Technical Memorandum

To: David Barker (Evolution Town Planning), Wayne Low (Eco Custom Homes)
From: Mike Potts (EnviroSolution)
CC:
Date: 26 September 2023
Re: Riverside residential development: Phase 2, Plot 8 layout change

Figure 2: Proposed development (drawing: 220203 - 00 - 014)

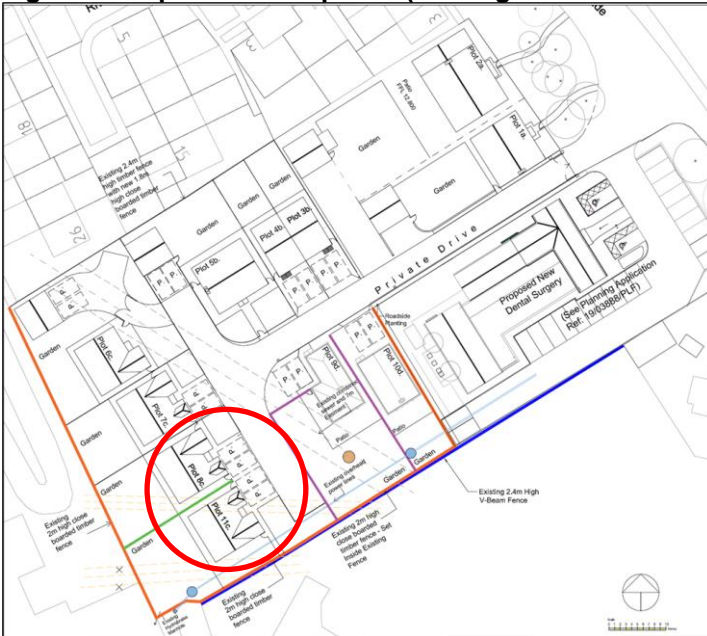
The update to the layout involves the splitting of Plot 8, at the site’s southern corner, to create 2 residential properties, Plots 8c and 8d, as indicated (circled) in Figure 2.

This change makes no difference to the findings of the previous assessments.
